RE: EPA Industrial Emissions Licensing Application P1181-02

On behalf of the applicant, Amazon Data Services Ireland Limited, and further information requested 5 September 2025 by the EPA, we submit further information and clarifications in respect of the licence review application P1181-02.

Figure 5.1 Extract from Surface Water Layout Plan

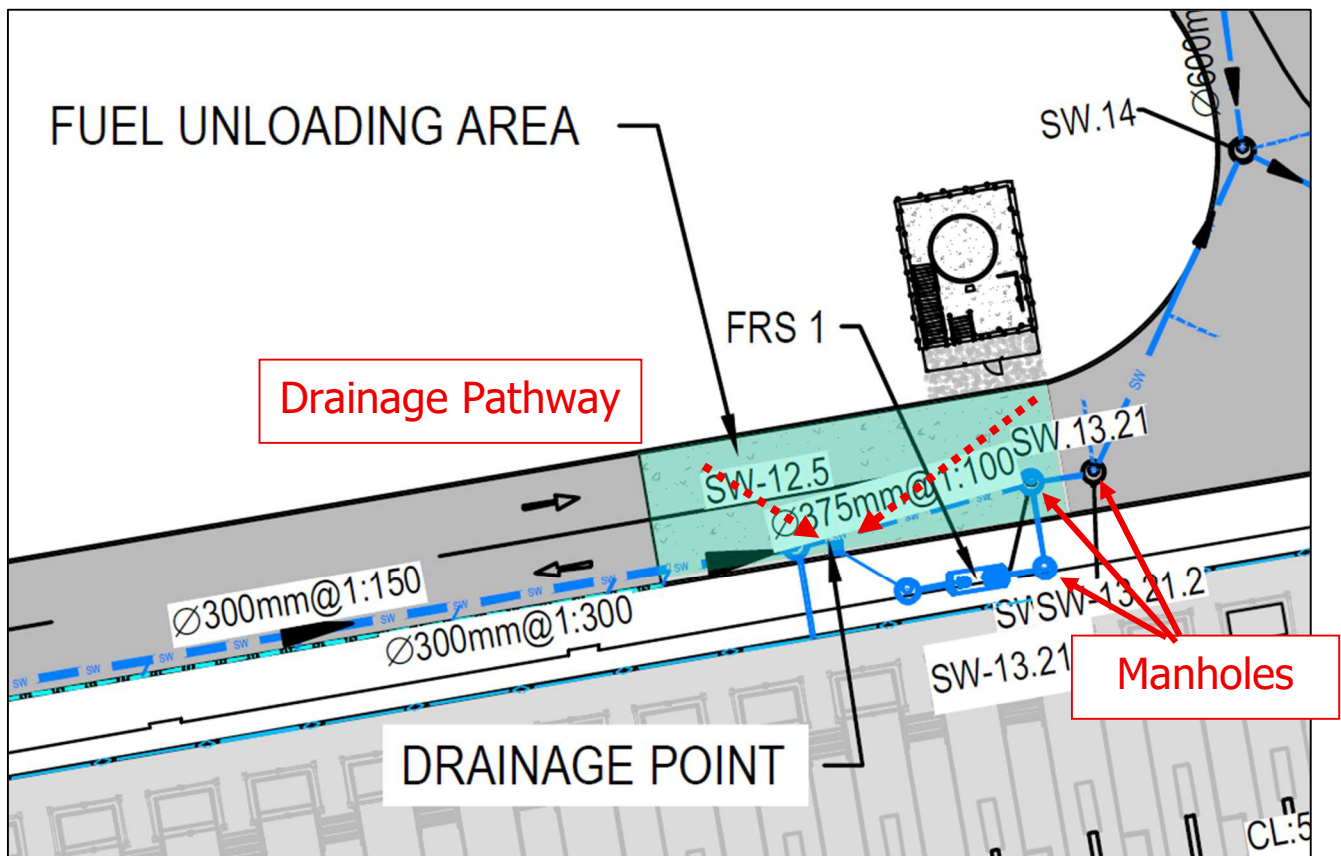
- Clarify if a climate change freeboard factor has been added to the 1 in 100 year rainfall event for the determination of the detention basin volume?
- Confirm that FRS1 is located downstream of the full 'Fuel Unloading Area' (as is with FRS2). The schematic 'Surface Water Layout Plan' appears to show a gully, in the 'Fuel Unloading Area', but downstream of the Class 1 interceptor leading to the detention basin.

It is confirmed that FRS1 is located fully downstream of the fuel unloading area for Building B. The "drainage point" at the fuel unloading area is shown on the Surface Water Layout Plan, this is the above ground collection point from drainage from the fuel unloading area, and directs stormwater via FRS1 before connecting with the main stormwater network. The circles shown downstream of the interceptors are covered manholes not drainage gully's see Figure 5.1 below.

Figure 6-1. Noise Contours for Scenario A (Figure 5 of Attachment 7-3-1-2 Noise)

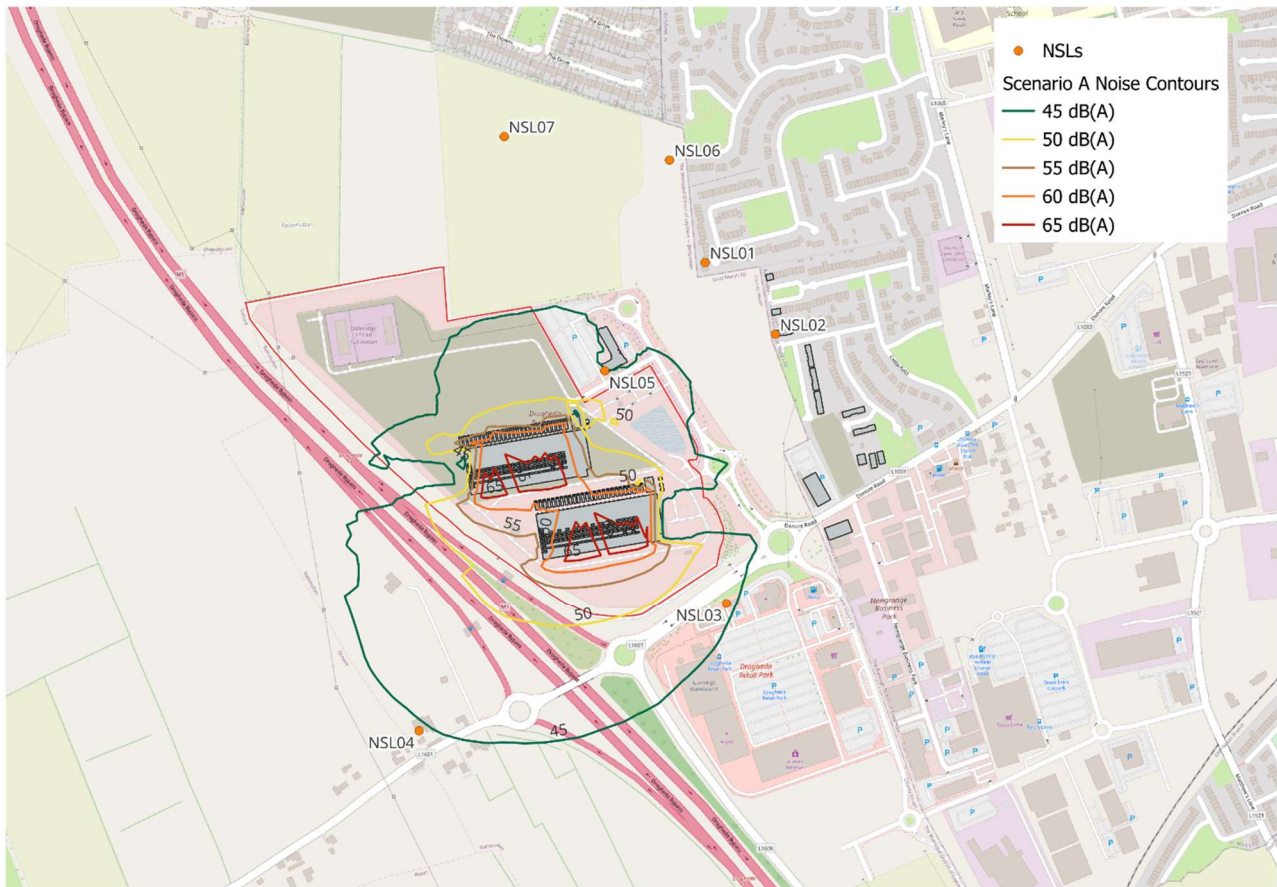
- Please resubmit Figure 6 and Figure 7 from Attachment-7-1-3-2 Noise Impact Assessment to include 45-50 dB(A) contours.
- Provide a map with proposed noise monitoring locations.
- Under 'Scenario B', the installation will not comply with the daytime, evening time and night time noise limits. Describe how the potential for exceedances will be managed and what mitigation measures will be implemented to ensure compliance with the relevant noise limits.

Figures 6-1, 6-2 and 6-3 show updated figures: Figure 5 Noise Contours for Scenario A, Figure 6 Noise Contours for Scenario B and , Figure 7 Noise Contours for scenario C; these are the same models as in the Attachment 7-3-1-2 Noise Impact Assessment submitted on 10 April 2025, with the background mapping and legends revised for clarity and with noise contours from 45 dB to 50 dB $L_{Aeq,T}$. included in each case.

Appendix A – Stormwater Outfall Location

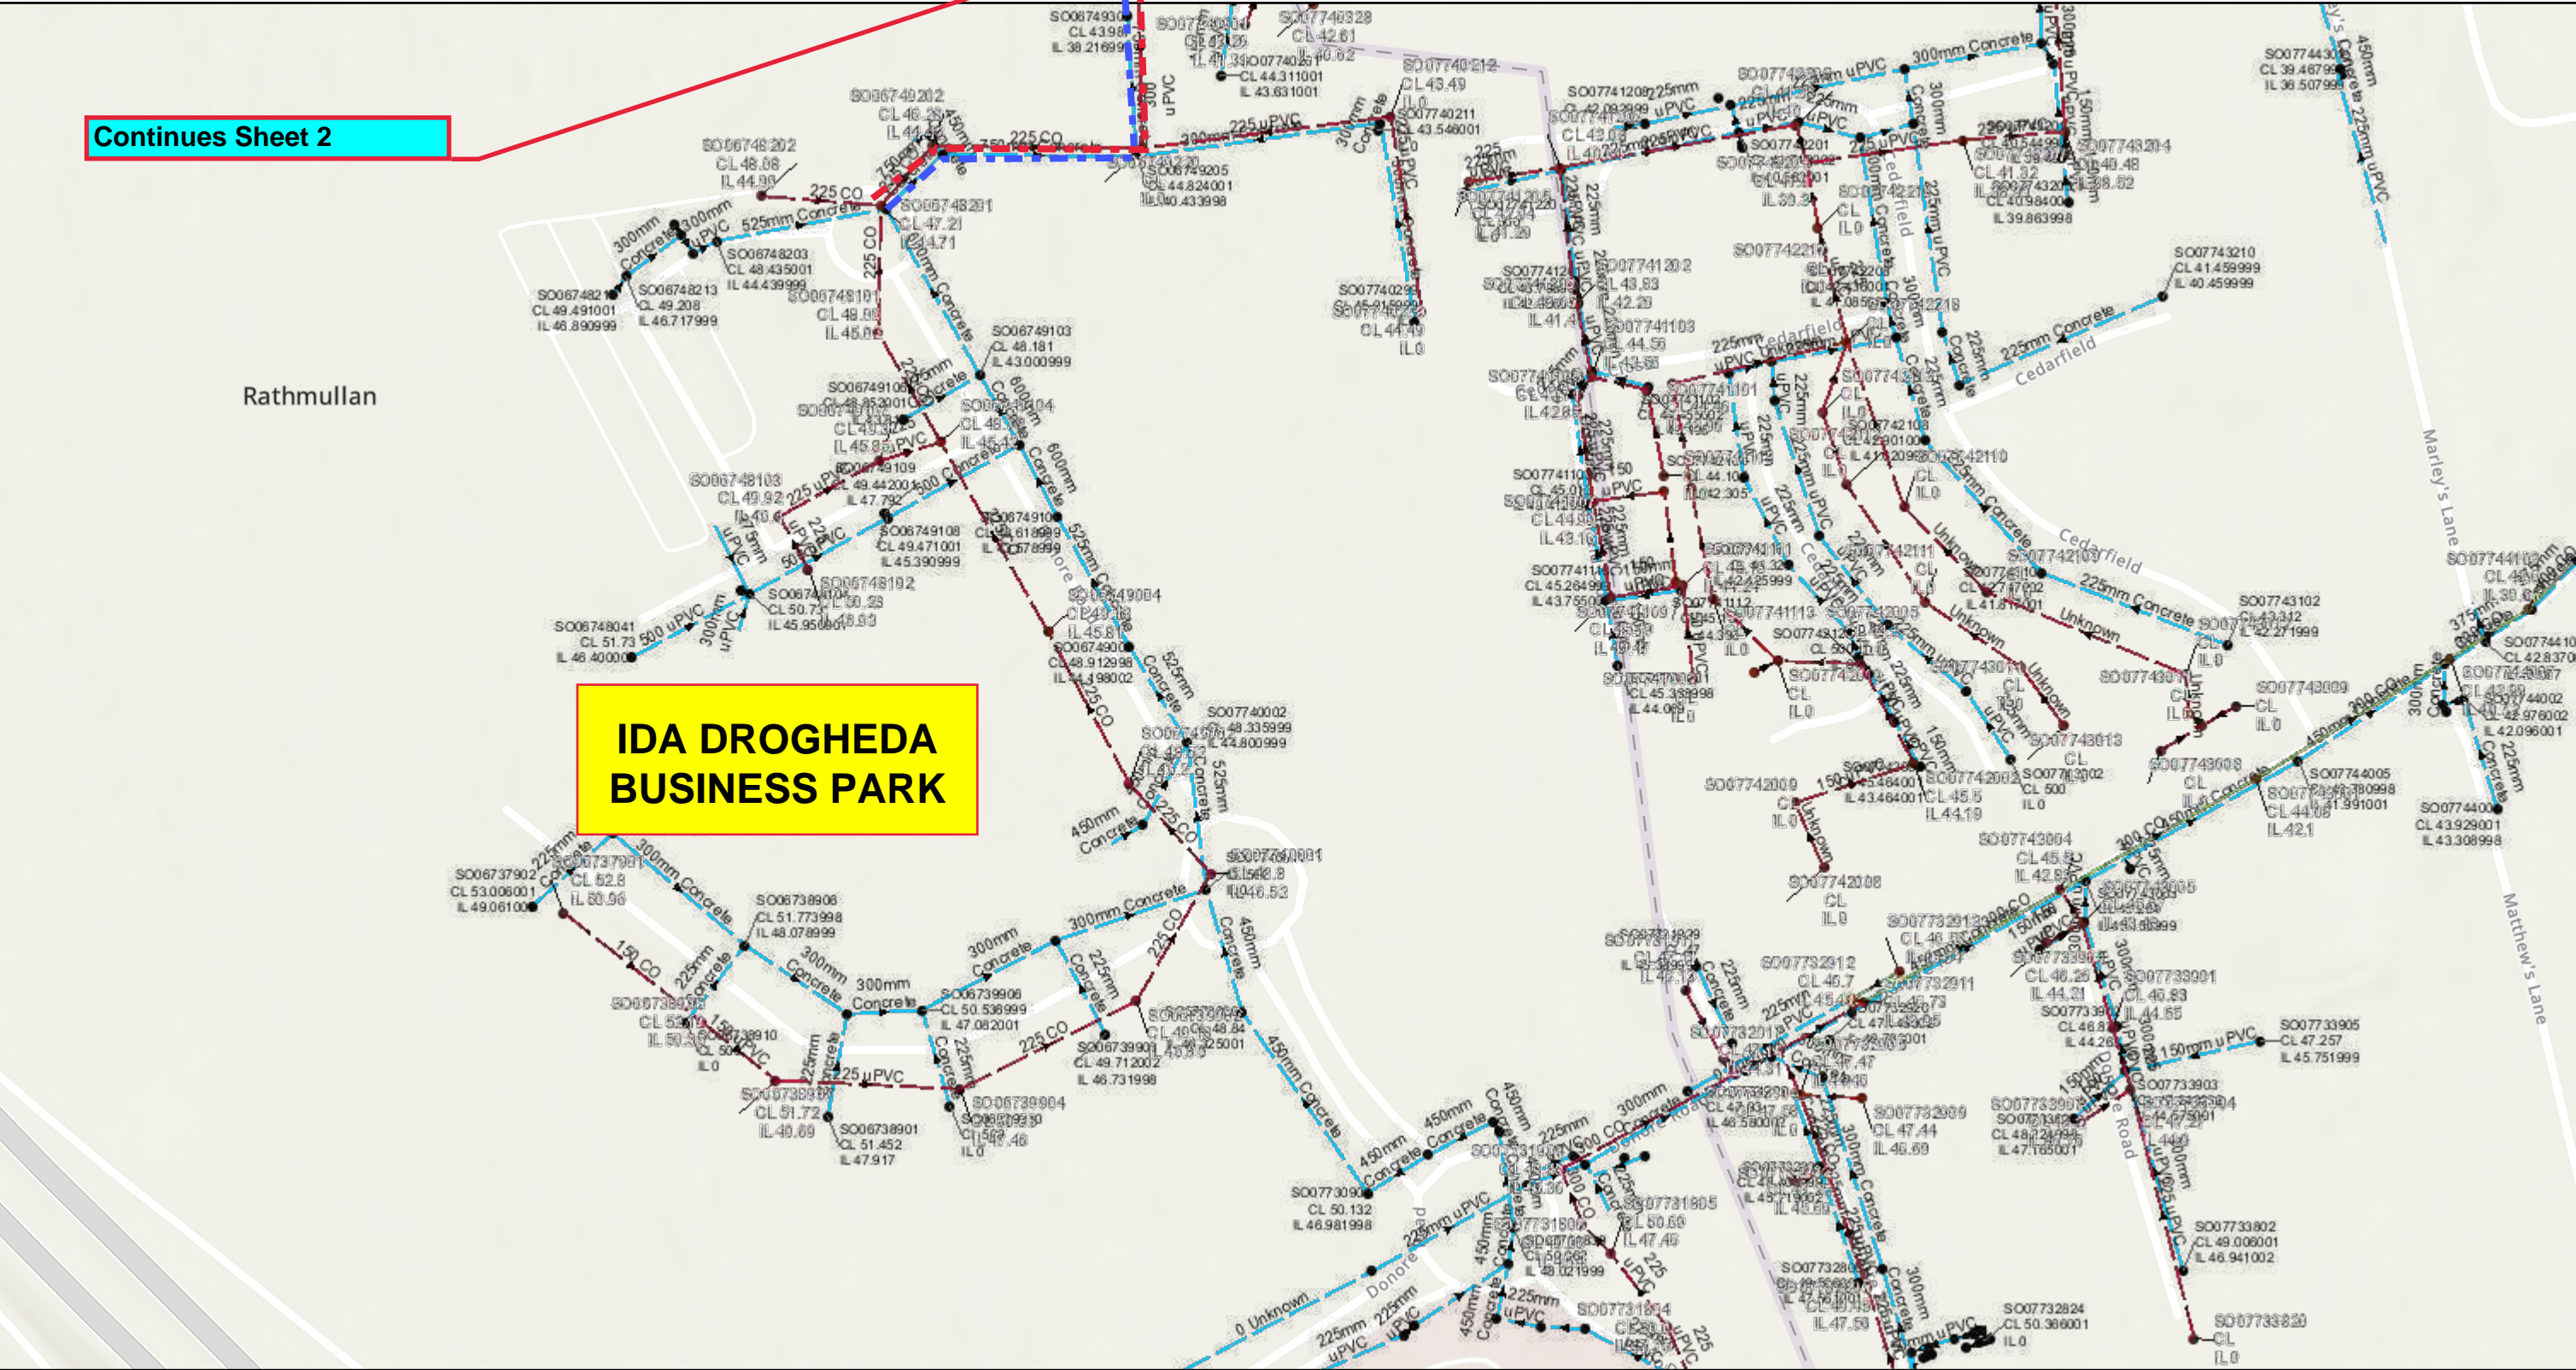
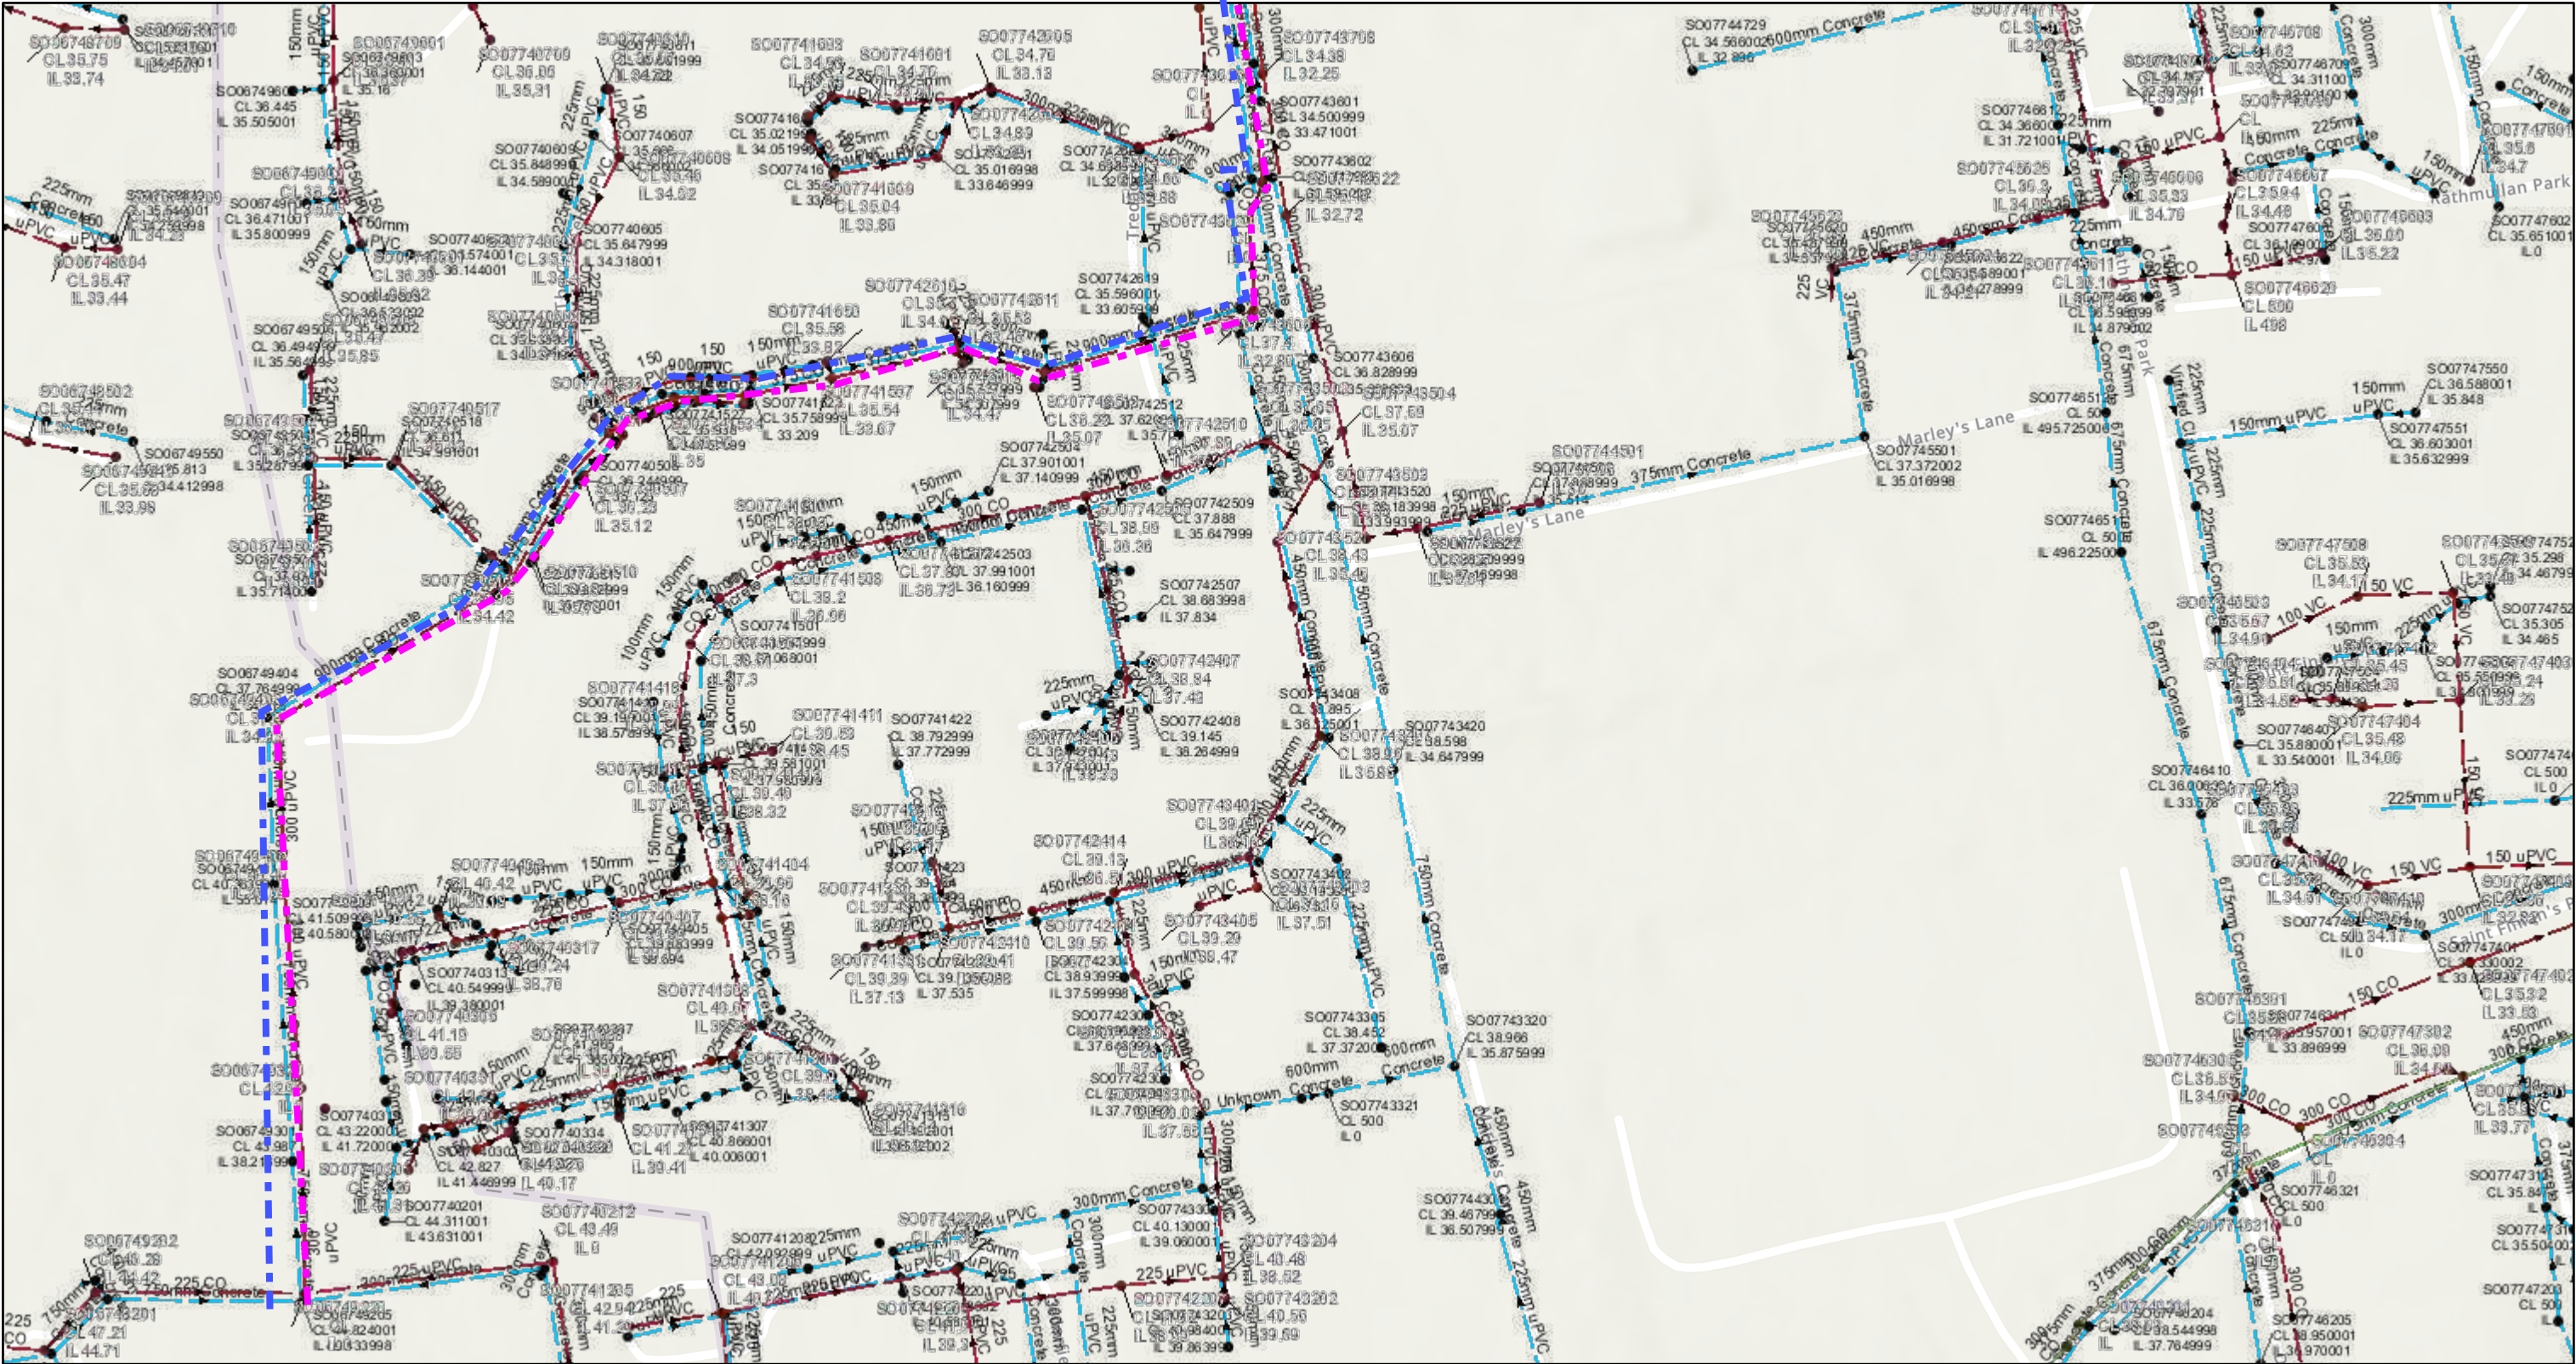
- Obtain, from the IDA, the exact location of the outfall of the IDA storm water network into the River Boyne, currently stated as 'not known' (Attachment 7-1-3-2 Surface Water and Ground Emissions Impact Assessment) to confirm storm water is discharged to where it is 'assumed' to discharge.

The storm water outfall location is shown in Appendix A. The drawings show the surface water drainage route from the IDA Park to the outfall located close to the Ramparts / St Dominics Park, approximately 1.5 km to the northeast of the site.
